MEMORANDUM

CITY OF WATERTOWN, NEW YORK
PLANNING AND COMMUNITY DEVELOPMENT DEPARTMENT
245 WASHINGTON STREET, ROOM 305, WATERTOWN, NY 13601
PHONE: 315-785-7741 – FAX: 315-782-9014

TO: Planning Board Members
FROM: Michael A. Lumbis, Planning and Community Development Director
PRIMARY REVIEWER: Geoffrey T. Urda, Planner
SUBJECT: Site Plan Approval – 155 Clinton Street
DATE: July 27, 2023
Request: Site Plan Approval to construct a 2,378 SF building addition, a 253 SF building addition and a 9,500 SF sq. ft. parking lot expansion at **155 Clinton Street**, Parcel Number 10-07-109.100
Applicant: Design Build Innovations, LLC
Proposed Use: Professional Office Building
Property Owners: Clinton Center Development, LLC

SHEET TITLE:
SITE PLAN AND LANDSCAPING PLAN

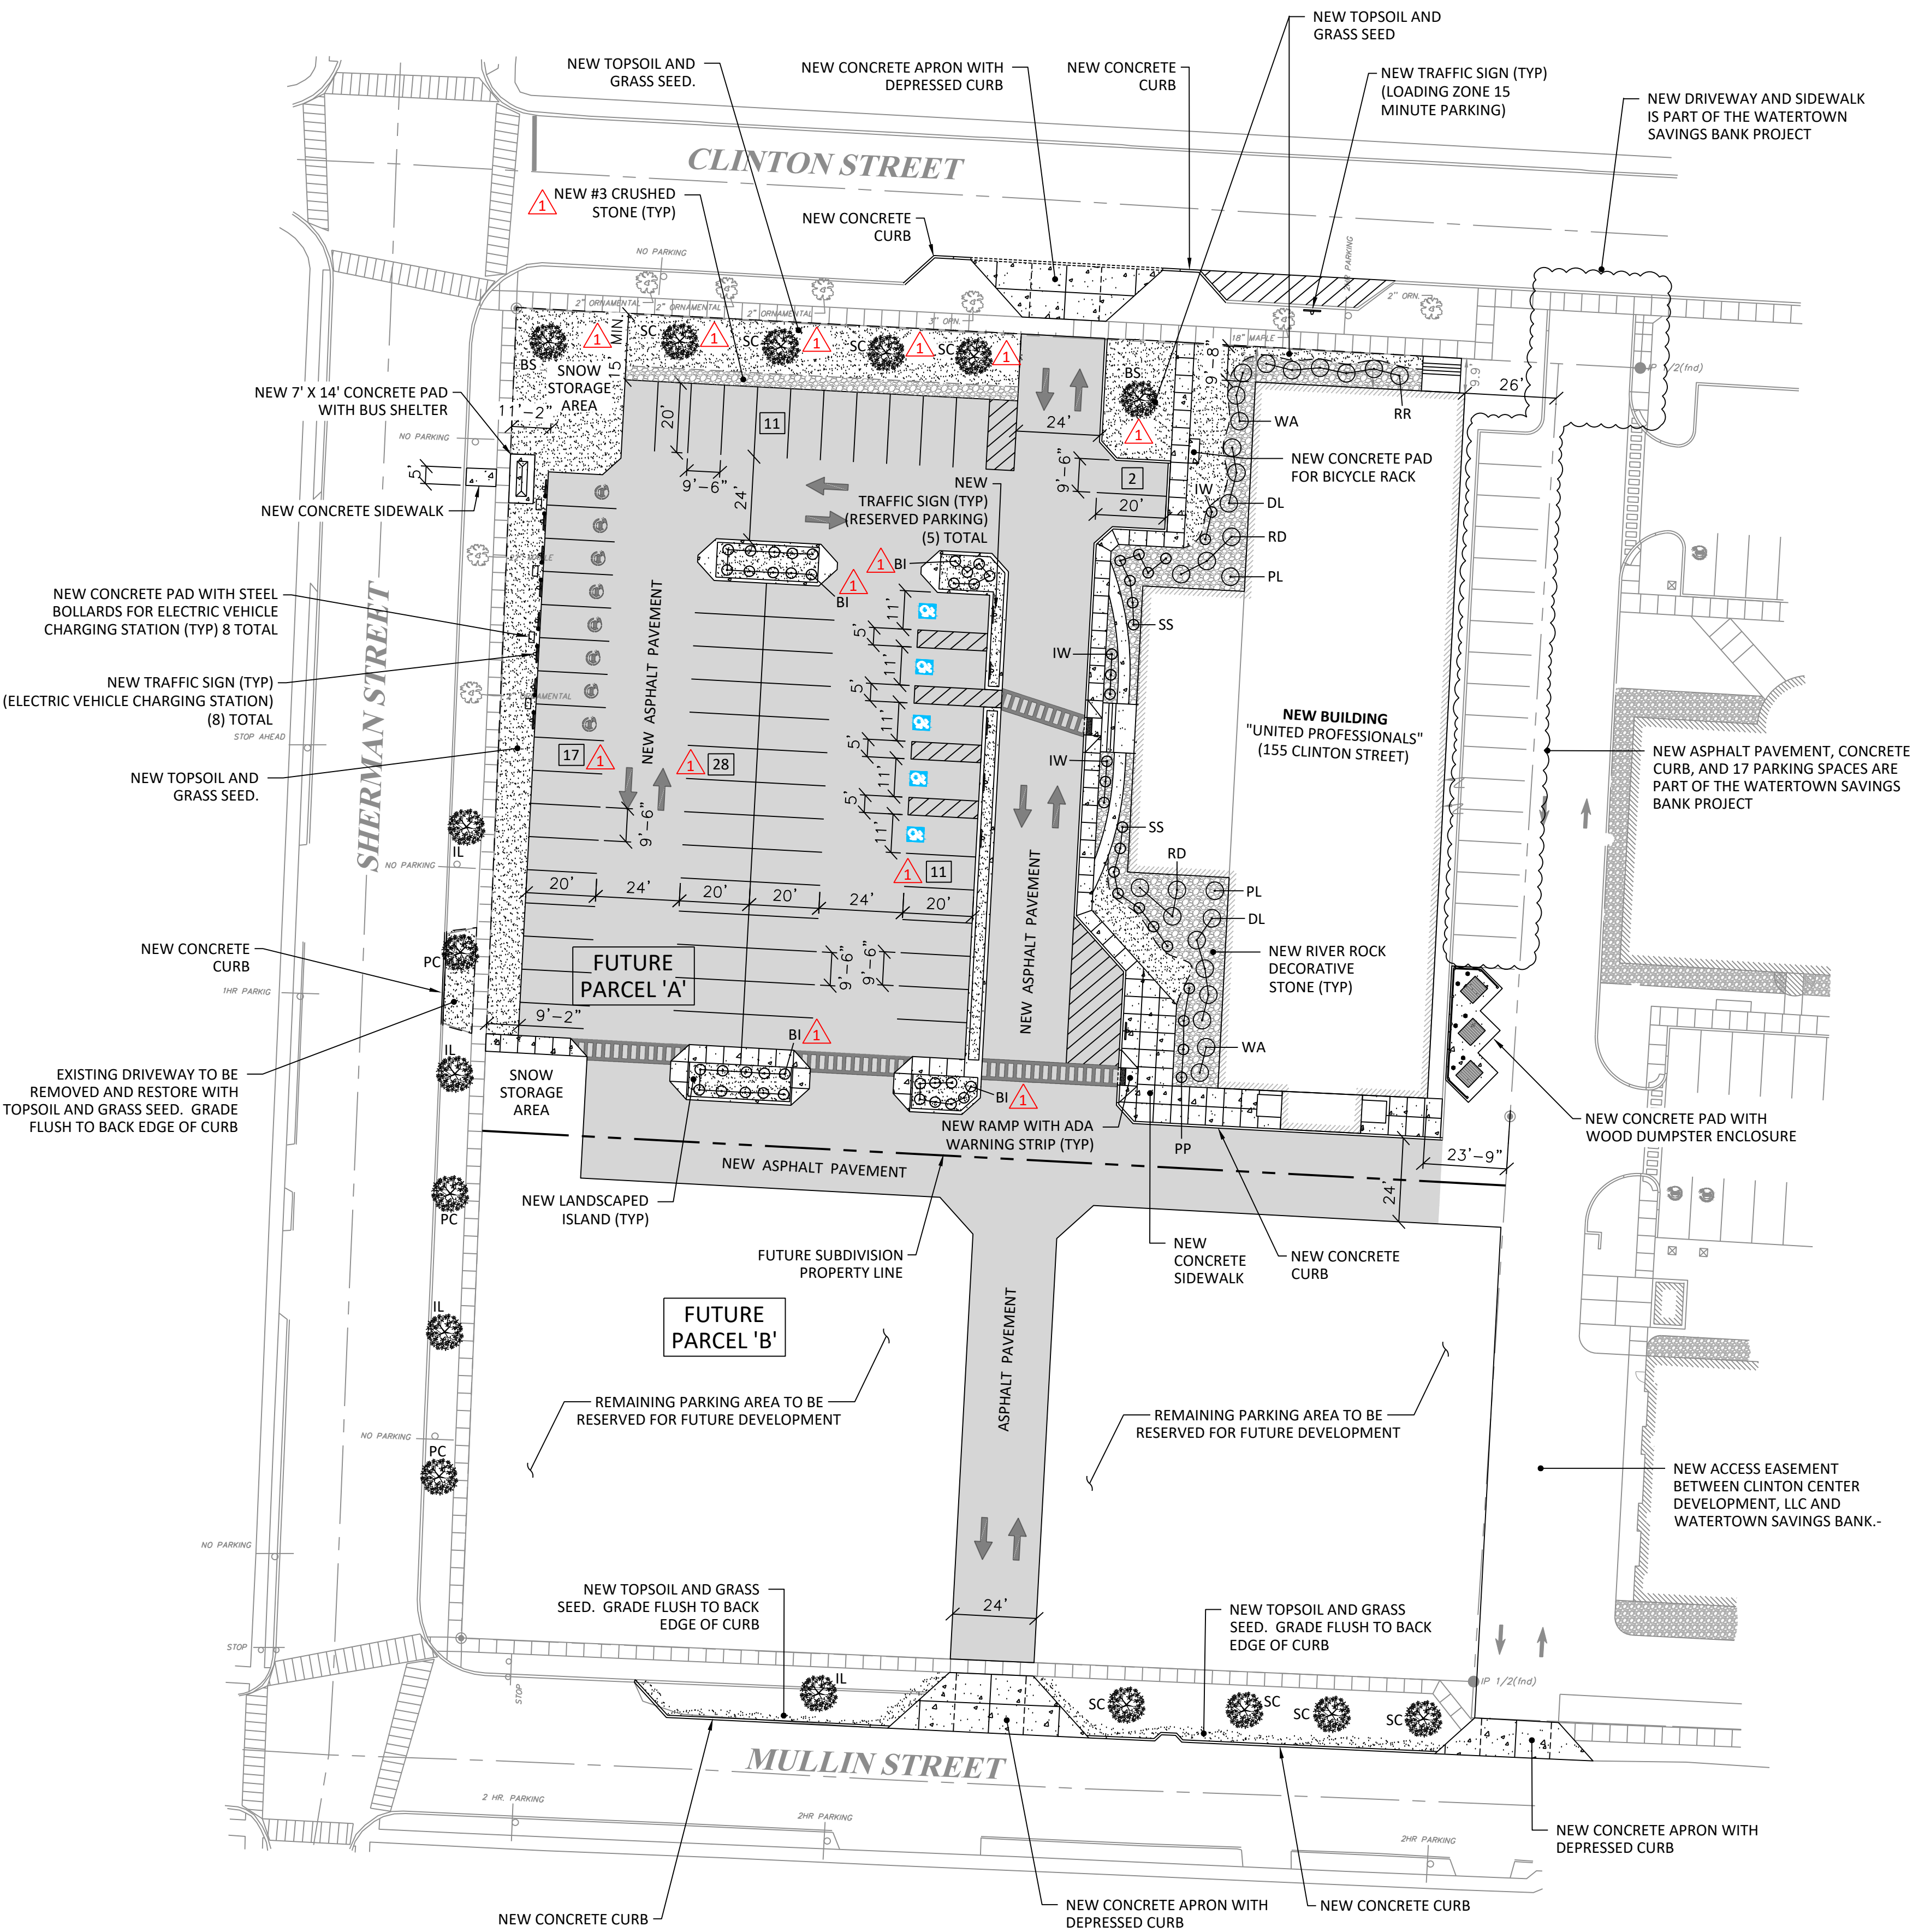
4. The applicant shall either add the movements of a City Fire Truck and a refuse/delivery vehicle to the C102 drawing or submit a formal Vehicular and Pedestrian Circulation Plan drawing. *This item is satisfied. The applicant has submitted a Vehicular and Pedestrian Circulation Plan that depicts all the required movements.*

10. The applicant shall add a label to either the C102 or C103 drawing that identifies whether the depicted contour lines are existing or proposed. *This item is satisfied. The applicant has updated the Legend on the C103 drawing that identifies the contour lines as existing contours.*

5. The applicant shall either provide a 15-foot-wide landscaped strip with trees along the Right-of-Way (ROW) on Clinton Street or apply for and obtain an Area Variance from the Zoning Board of Appeals granting relief from this requirement. *The applicant has added the required 15-foot-wide landscaped strip to the site plan however the proposed spacing of the small to medium deciduous trees is 30'. The Zoning Ordinance requires small to medium deciduous trees to be provided every twenty (20) linear feet. This summary item must remain but should be reworded as the following:*

6. The applicant shall either add interior parking lot trees to the Landscaping Plan to meet the requirements of the Zoning Ordinance or apply for and obtain an Area Variance from the Zoning Board of Appeals granting relief from the requirements. *The applicant states in their July 19, 2023 correspondence that “plantings/shrubbery” have been added to the site plan inside the landscaped islands. However, the applicant is still not proposing any interior parking lot trees. To be consistent in the application of the landscaping requirements of the zoning ordinance for existing sites, the City will only require interior parking lot trees based on the extent of the expanded (new) parking area. The new parking area consists of eleven spaces along Clinton St. and two spaces near the northwest corner of the building addition for a total of thirteen. One large deciduous tree must be provided for each fifteen parking spaces or any fraction thereof. This summary item must remain but should be reworded as the following: The applicant must provide one interior parking lot tree within a landscaped island in the parking area.*

16. The applicant shall depict and label all existing and proposed fire hydrants on the plan drawing. *There is an existing hydrant on Clinton Street that is not depicted on any plan drawings.*

Finally, while the table identifies 89 spaces, the site plan drawing appears to contain 90 spaces. The applicant shall clarify this discrepancy.

Vehicular and Pedestrian Circulation: The applicant did not submit a formal Vehicular and Pedestrian Circulation Plan, which is a required drawing within a Site Plan Application package. The C102 (Site Plan) drawing contains some of the required elements of a Vehicular and Pedestrian Circulation Plan. However, it does not contain the movements of a City fire truck and a refuse vehicle. The analysis below is based on the information available on the C102 drawing.

The applicant is proposing a 9'-3"-wide landscaped strip along the ROW on Clinton Street, 5'-9" narrower than the Zoning Ordinance requires. Since this is a new parking area, the applicant is responsible for meeting all applicable requirements of the Zoning Ordinance and must increase the width to 15 feet.

The applicant proposes four interior landscaped islands as well as a landscaped area adjacent to the west façade of the building. However, the applicant only proposes topsoil with grass seed for the former and decorative stone gravel with shrubs for the latter.

“The applicant shall provide small to medium deciduous trees at a spacing of 20’ within the landscaped strip adjacent to the Right-of-Way (ROW) on Clinton Street.”

SHEET TITLE:
VEHICULAR AND PEDESTRIAN CIRCULATION PLAN

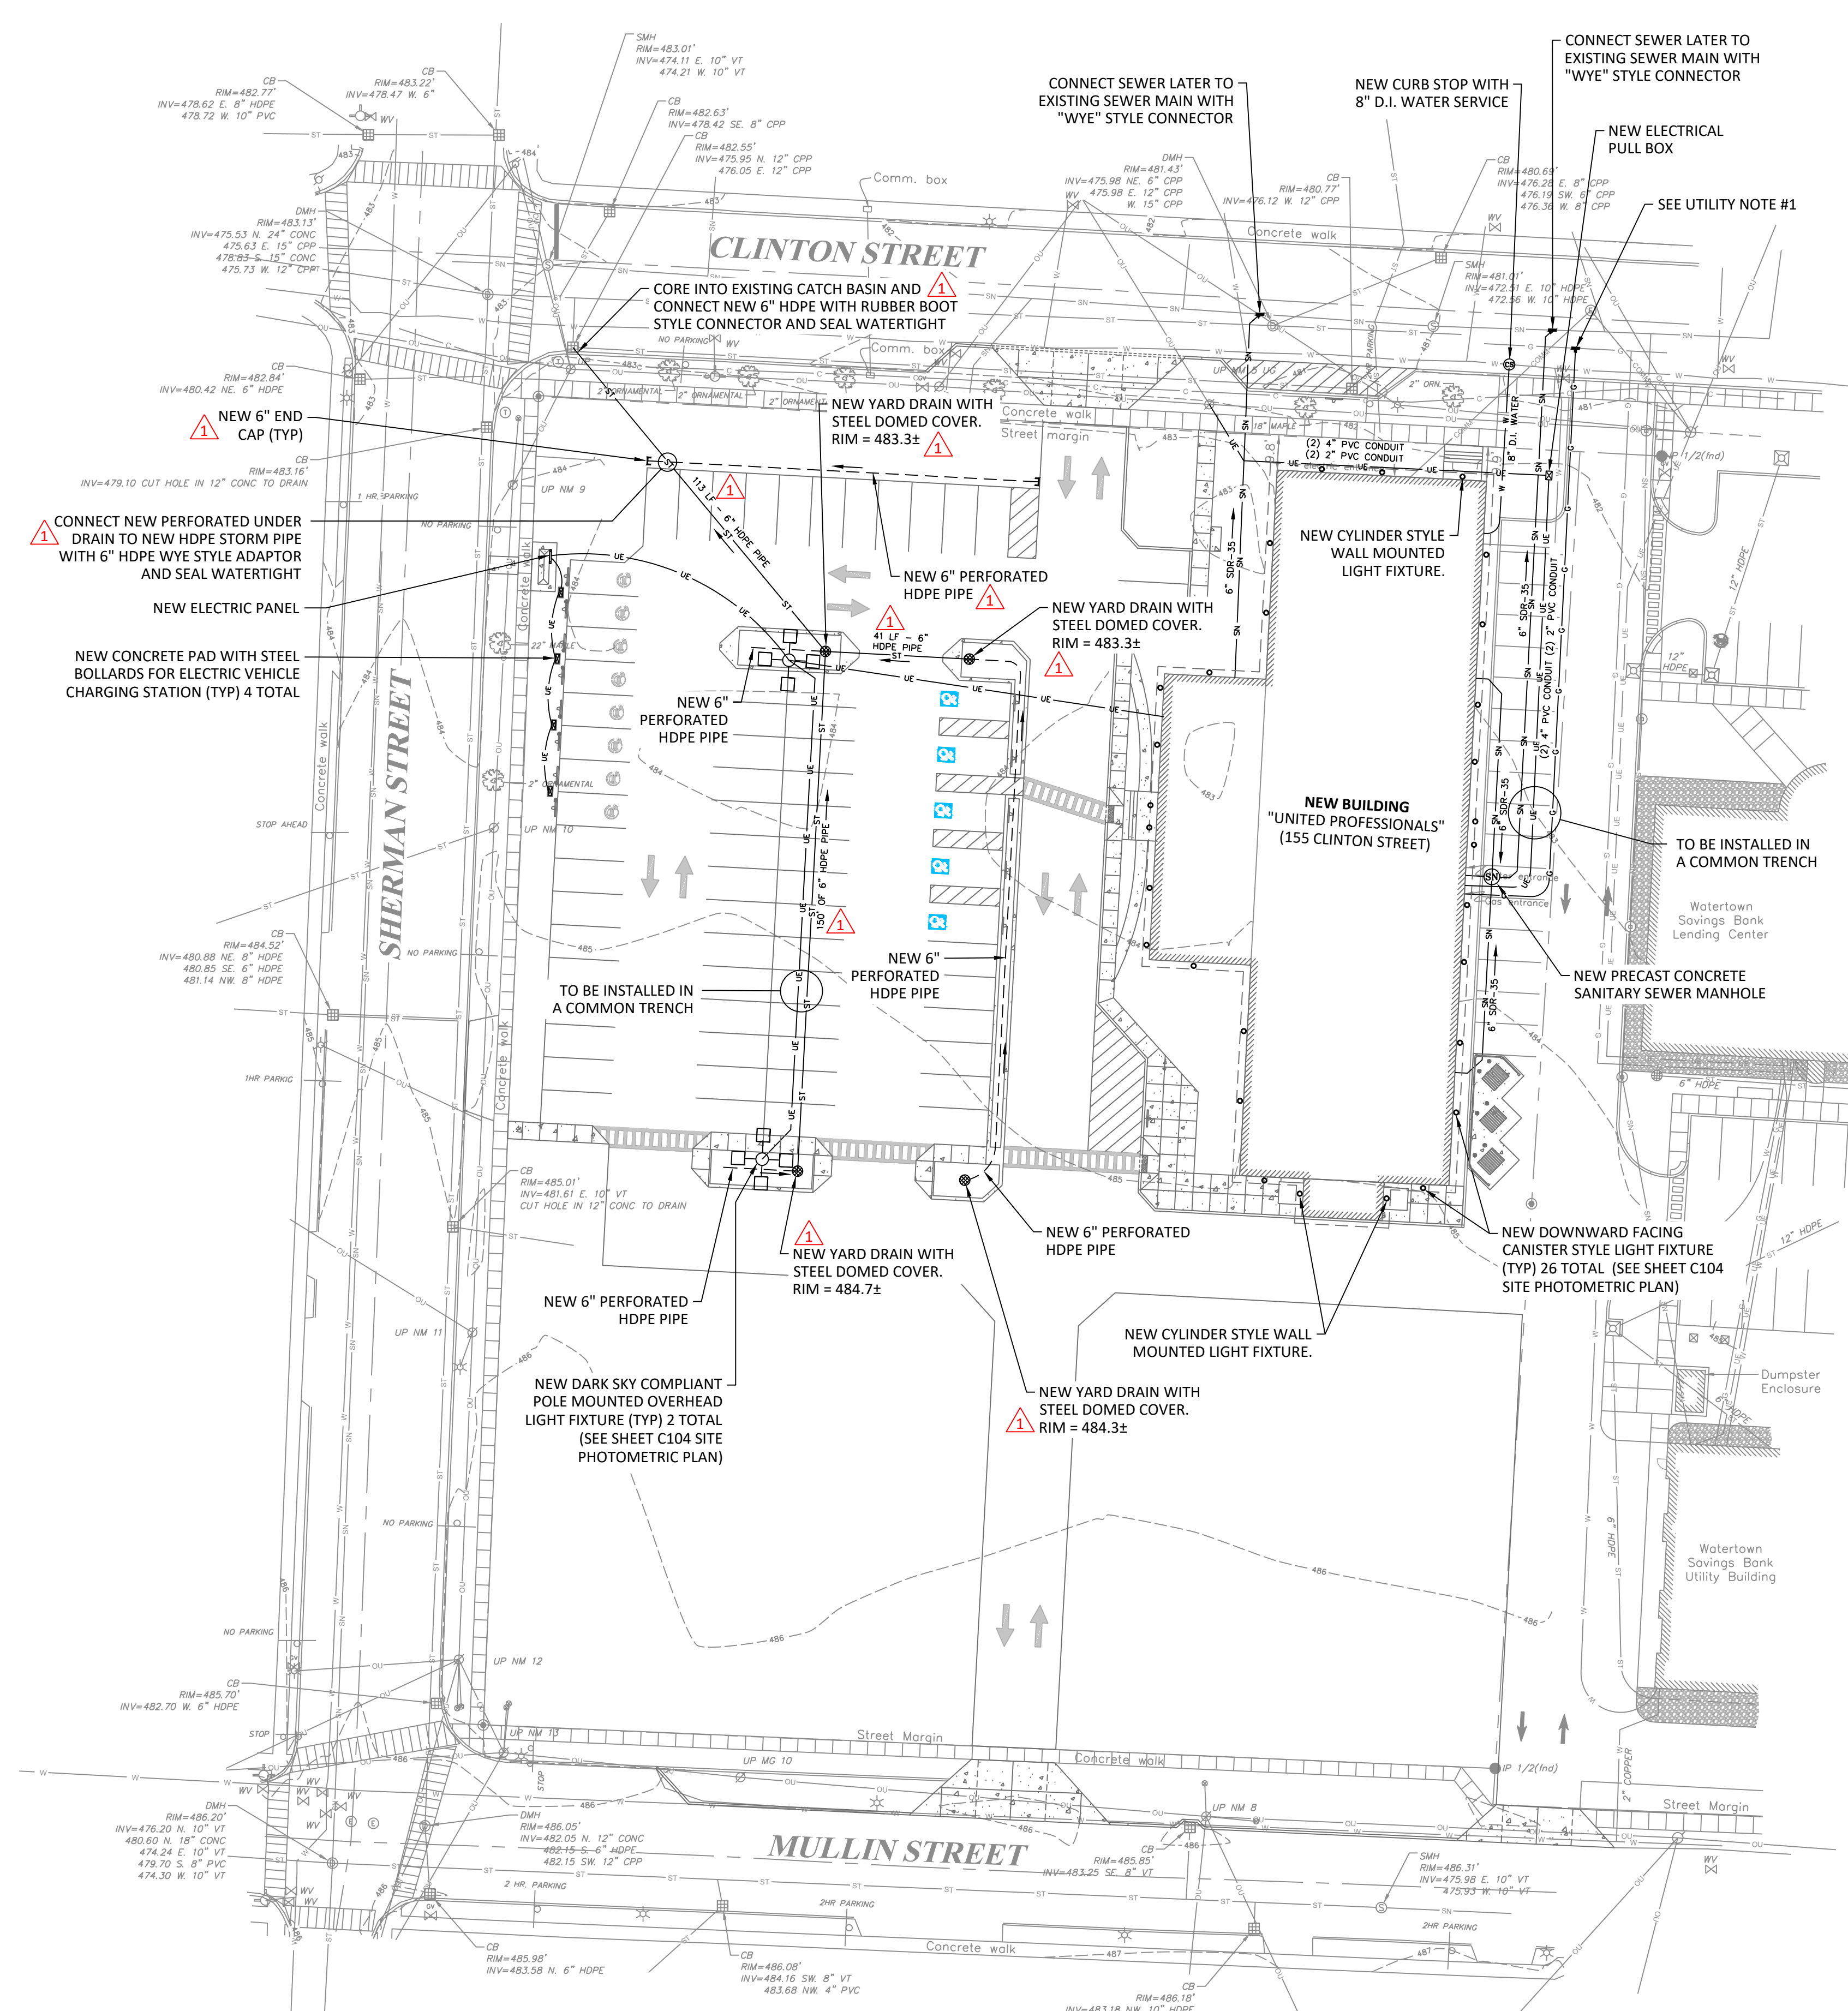
The applicant has submitted a Vehicular and Pedestrian Circulation Plan to comply with Summary Item #4. This drawing depicts pedestrian access from Clinton Street and Sherman Street in the form of an internal sidewalk network that connects to both streets' public sidewalks. If/when the Planning Commission considers a development proposal for the south end of the site, it should require the internal sidewalk network to connect to the Mullin Street sidewalk. The applicant also proposes a bus shelter on the Sherman Street edge of the property, which is laudable. The shelter would serve the CitiBus system.
